CURVATURE CORRECTED BANDGAP CIRCUIT

S/N 10/808,635

AMENDMENT

In response to the Office Action of October 20, 2006, please amend the above-identified application as follows:

REPLACEMENT DRAWING

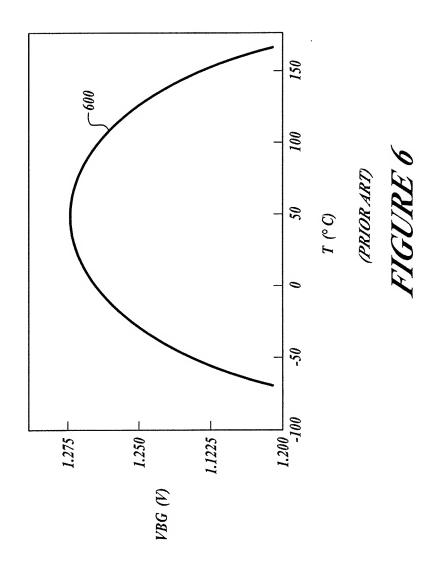
FIG. 6 is objected to for failing to have a designation of "PRIOR ART". A replacement

sheet for FIG. 6 is included with this response, where the replacement sheet has the designation

of "PRIOR ART." It is believed that the objection to FIG. 6 is overcome by this amendment and
